Subject: **Response to Portion of NRC Request for Additional Information
Letter No. 294 Related to ESBWR Design Certification Application -
Auxiliary Systems - RAI Number 9.2-24**

**RESPONSE TO PORTION OF NRC REQUEST FOR
ADDITIONAL INFORMATION LETTER NO. 294
RELATED TO ESBWR DESIGN CERTIFICATION
APPLICATION**

RAI NUMBER 9.2-24

Table 2 – RAI 9.2-24 Audit Items and GEH Response

ATTACHMENT 1, TYPICAL Chilled Water System Instrumentation

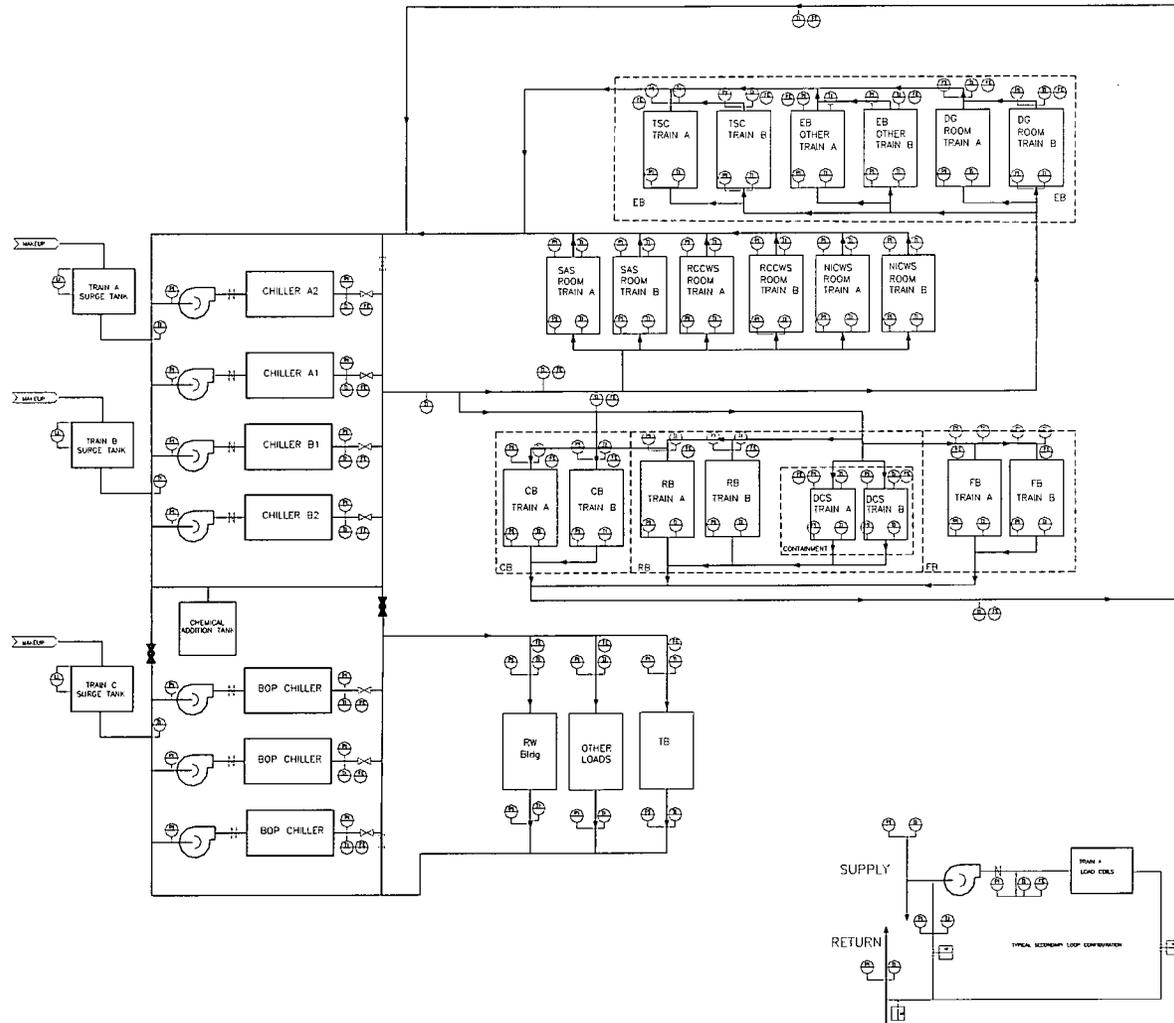
In addition, Figure 2 from SR3-1-ECA-0036 (Rev. 0) is provided as reference to indicate instrument locations in support of GEH response to audit item b.4 for NICWS.

Figure 9.2-1. Plant Service Water System Simplified Diagram

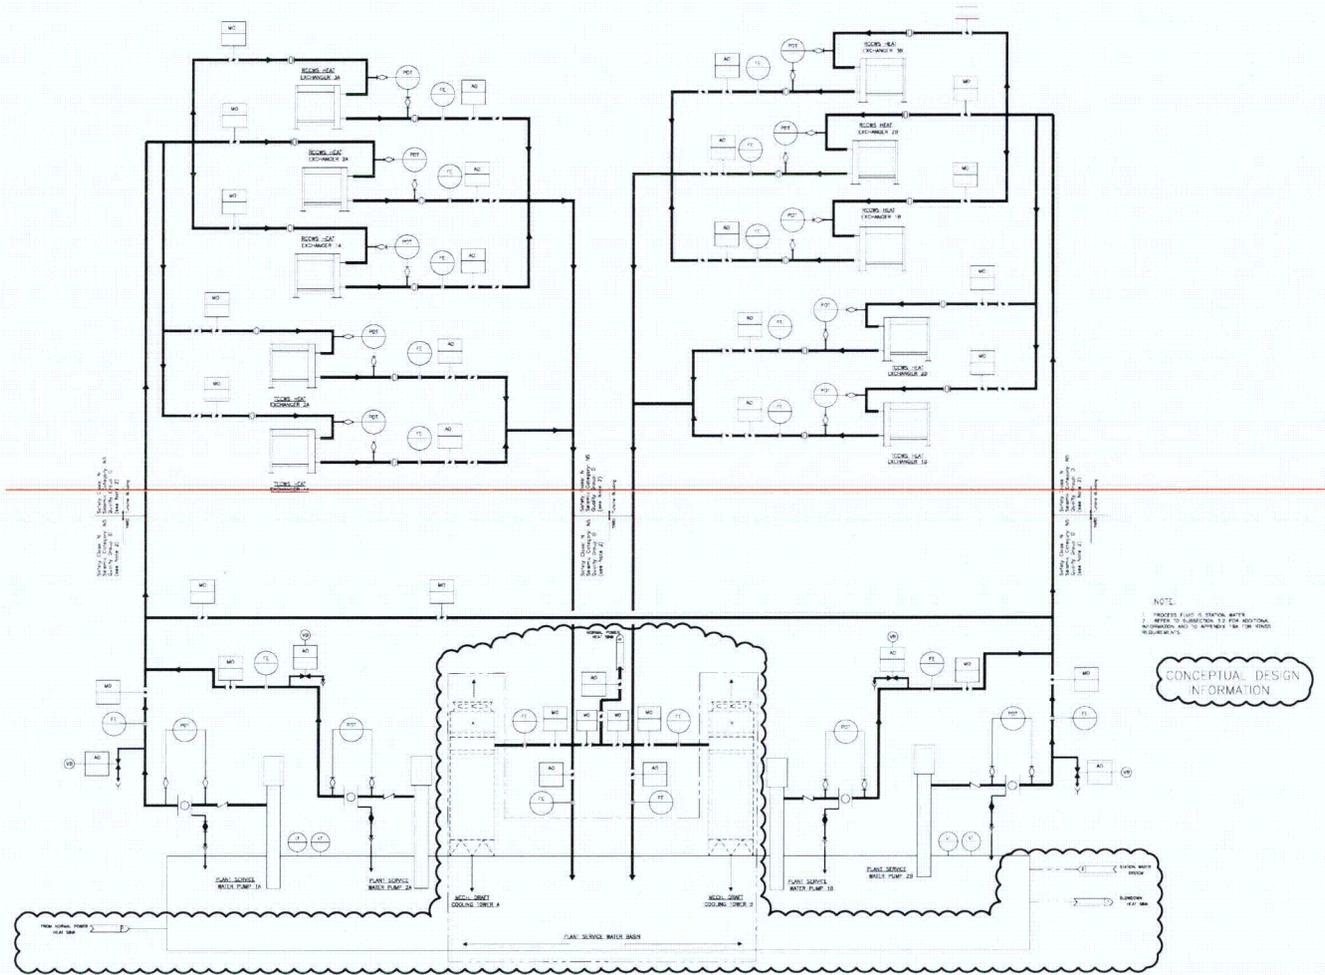
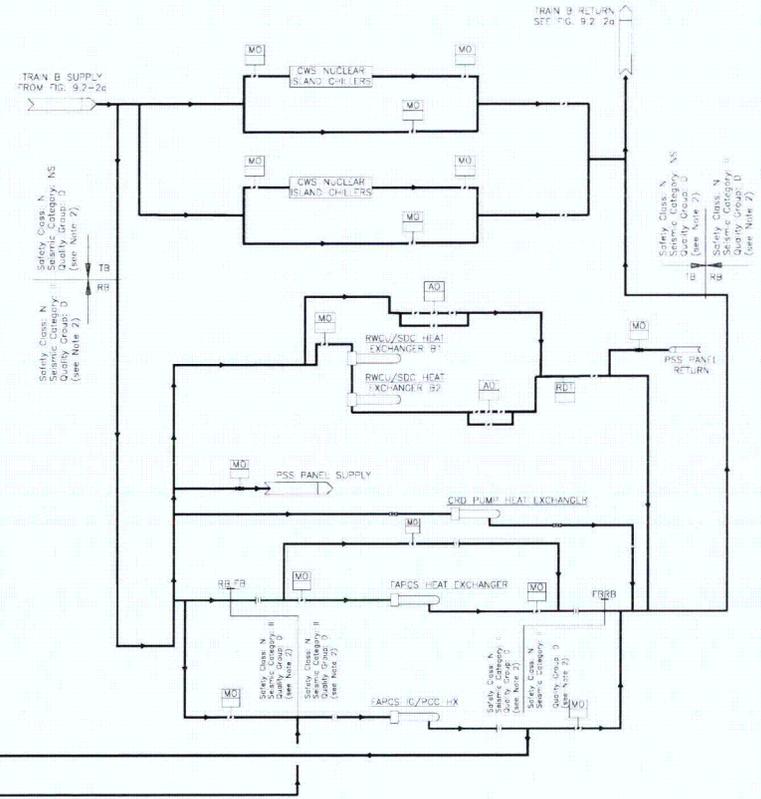
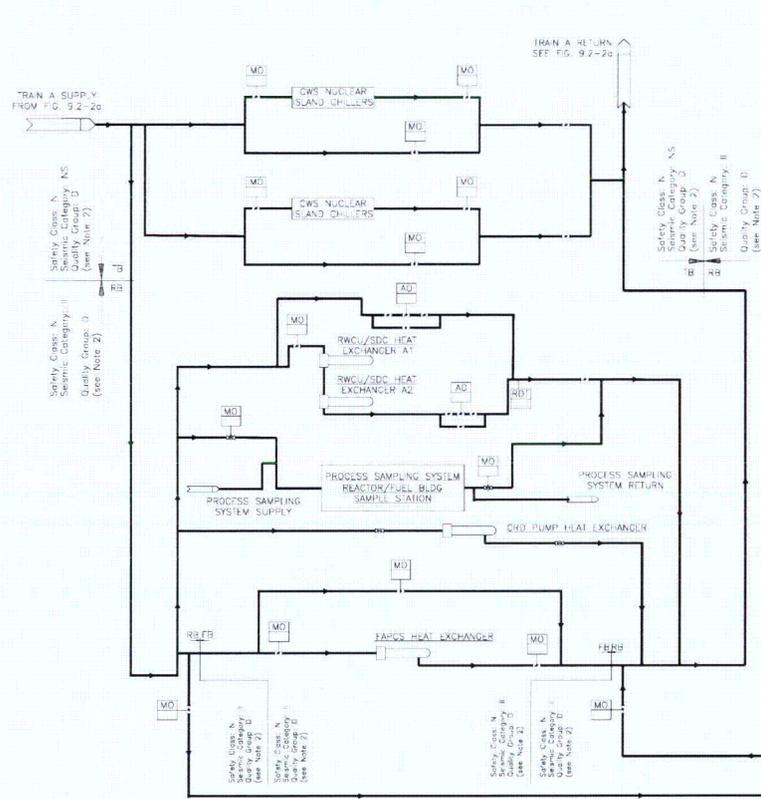
<ul style="list-style-type: none"> <i>Although the description indicates that vacuum breakers will be installed at high points in system piping, none are shown on the system drawings. The system drawing needs to be revised to indicate where the high points are and to show the vacuum breakers, including where vacuum breakers are located in the heat rejection facility piping. Furthermore, an information item needs to be established for COL applicants to include vacuum breakers in the plant-specific heat rejection facility piping.</i> 	b.15	b.15	b.15
<ul style="list-style-type: none"> <i>DCD Tier 2 Section 9.2.1.5, "Instrumentation Requirements," indicates that with one PSWS pump operating, the respective standby pump starts automatically upon detection of a low system pressure signal in that train, loss of electric power to the operating pump, or an operating pump trip signal. This section also indicates that starting a PSWS pump automatically opens a flow path through the RCCWS and TCCWS heat exchangers. However, no description is provided under the operation discussion in Section 9.2.1.2, "System Description," about these operating features, and there is no discussion about operation of the self-cleaning strainers.</i> 	b.16	b.16 (for I&C consistency)	b.16 (for I&C consistency)

RAI 9.2-24 NRC Audit Items, PSWS	GEH Response to Audit Findings/Comments, PSWS
	<p>DCD Tier 2 Figure 9.2-1 will be revised in Rev 6 to replace the automatic check type air release/vacuum valve symbol with a VB in accordance with the ESBWR P&ID Specification SR3-A10-PID-1002, and DCD Tier 2, Figure 1.7-1.</p> <p>GEH considers sufficient information is provided in this response to resolve this issue. DCD updates will be included for this issue.</p>
<p>b.16 Review the supplied documents and drawings for DCD consistence between sections related to instruments. DCD Tier 2 Section 9.2.1.5, "Instrumentation Requirements," indicates that with one PSWS pump operating, the respective standby pump starts automatically upon detection of a low system pressure signal in that train, loss of electric power to the operating pump, or an operating pump trip signal. This section also indicates that starting a PSWS pump automatically opens a flow path through the RCCWS and TCCWS heat exchangers. However, no description is provided under the operation discussion in Section</p>	<p>The NRC reviewed the current Phase 1 Design P&IDs and proprietary PSWS P&IDs updated for the PSWS Value Added Board. In addition, the NRC reviewed the Plant Service Water System Design Specification (SR3-1-P41-SDS-6401). ESBWR DCD Tier 2, Subsections 9.2.1.2 and 9.2.1.5 address instrumentation and control design performance requirements for the PSWS. Including the same description of PSWS operation would be redundant.</p> <p>PSWS pump operation is described in the Plant Service Water System Design Specification (SR3-1-P41-SDS-6401). PSWS pumps are manually started and stopped from the MCR. The pump start is permitted when the PSWS basin level is not low. Normally, one PSWS pump is in operation in each train and the other is in standby. The pump trips if the pump discharge valve fails to open or upon low pump discharge pressure. The standby pump automatically starts when the running pump trips in the same train. In the event of a LOPP, the pumps are sequenced to automatically start.</p> <p>The RCCW System Design Specification (SR3-1-P21-SDS-6399) describes interlock logic between PSWS flow signal and RCCW heat exchanger isolation valves. The RCCW heat exchangers not in use have the cooling water supply</p>

Figure 9.2-3. Chilled Water System Simplified Diagram

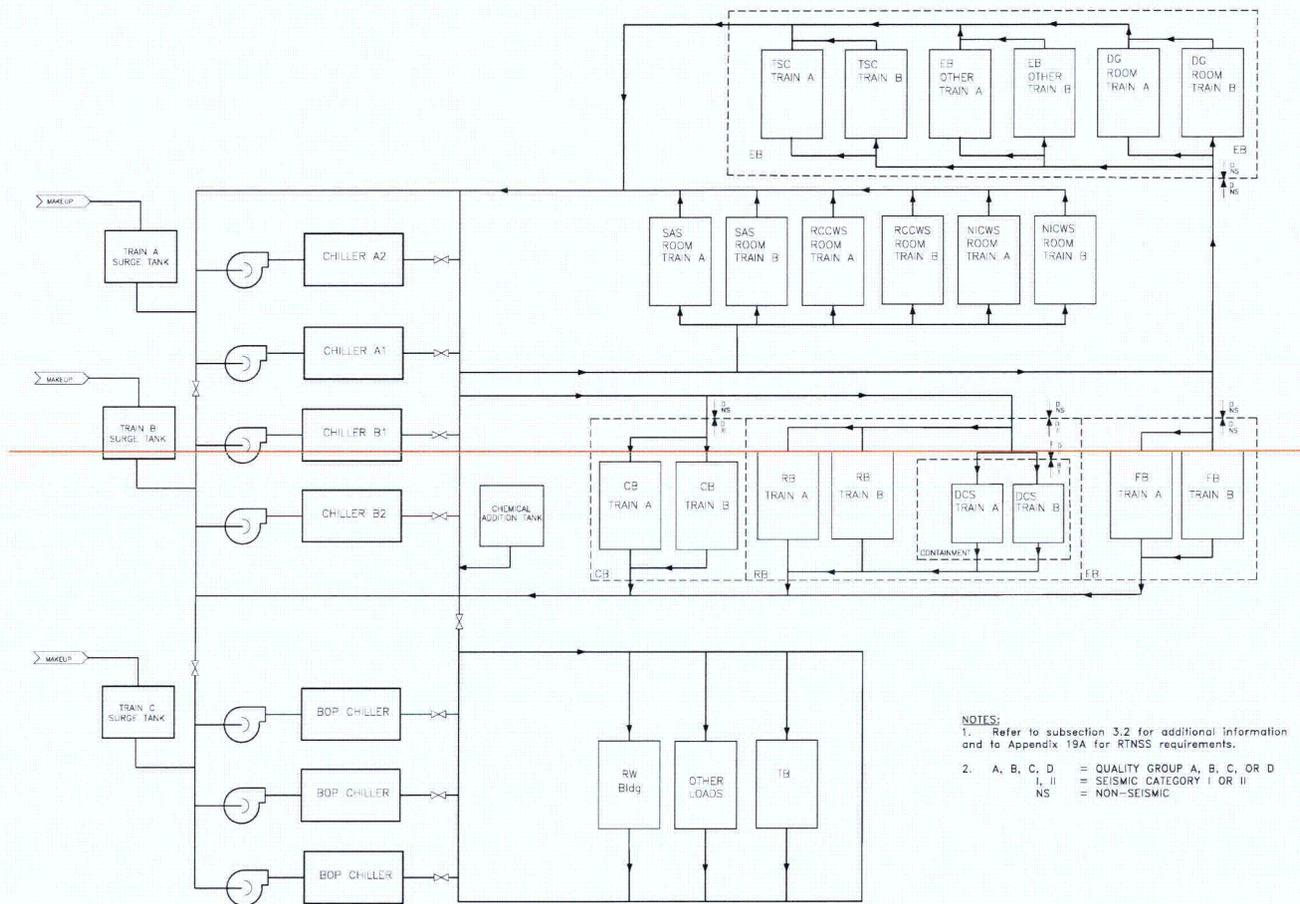
<p>The NRC staff questioned the ASME class breaks for CWS containment isolation noted on DCD Figure 9.2-3, Chilled Water System Simplified Diagram. As listed in DCD tier 2, Table 3.2-1, Classification Summary, NICWS</p>		50 mm (2 in.)	200 mm (8 in.)	350 mm (14 in.)	500 mm (20 in.)	>600 mm (24 in.)	Pump Suction	2 fps	5 fps	6 fps	8 fps	10 fps	Pump Discharge	5 fps	10 fps	12 fps	15 fps	15 fps
	50 mm (2 in.)	200 mm (8 in.)	350 mm (14 in.)	500 mm (20 in.)	>600 mm (24 in.)														
Pump Suction	2 fps	5 fps	6 fps	8 fps	10 fps														
Pump Discharge	5 fps	10 fps	12 fps	15 fps	15 fps

RAI 9.2-24 NRC Audit Items, NICWS	GEH Response to Audit Findings/Comments, NICWS
	<p>DCD Figure 9.2-3, Chilled Water System Simplified Diagram, is updated under revision 6 to illustrate the mixing valve configuration for a secondary loop arrangement and reflect air-operated bypass control valves across the supply and return lines. DCD updates will be included for this issue.</p>
<p>b. 6 Review the supplied documents and drawings for related to the air system interface for the air-operated valves. Review for how train separation is maintained and reliability of this air system arrangement.</p> <p>Determine what needs to be included in the DCD.</p>	<p>The NRC reviewed the preliminary Phase 1 Design piping diagrams associated with Engineering Change SR3-1-ECA-0036, Optimization of the Chilled Water System (P25). In addition, the NRC reviewed the Chilled Water System Design Specification (SR3-1-P25-SDS-6417).</p> <p>As described in response to b.3 above, DCD subsection 9.2.7.1 states that the CWS is designed so that a single active failure or malfunction of one NICWS train does not affect system functionality. In case of failure, the system automatically generates a train isolation signal. Detail design will ensure valve failure modes will allow achieving this design requirement.</p> <p>As described in the Chilled Water System Design Specification (SR3-1-P25-SDS-6417), air operated valves are specified for the NICWS bypass control valves, NICWS surge tank makeup valve and NICWS user air control valves.</p> <p>The CWS air-operated bypass control valves are modulated on the basis of the differential pressure across the supply and return lines to regulate the NICWS and BOPCWS chilled water supply. The bypass valves also have the ability to be controlled manually from the MCR N-DCIS and the bypass valve fails close.</p> <p>CWS chilled water user air-operated control valves are modulated on the basis of cooling demand from the users. The valves also have the ability to be</p>
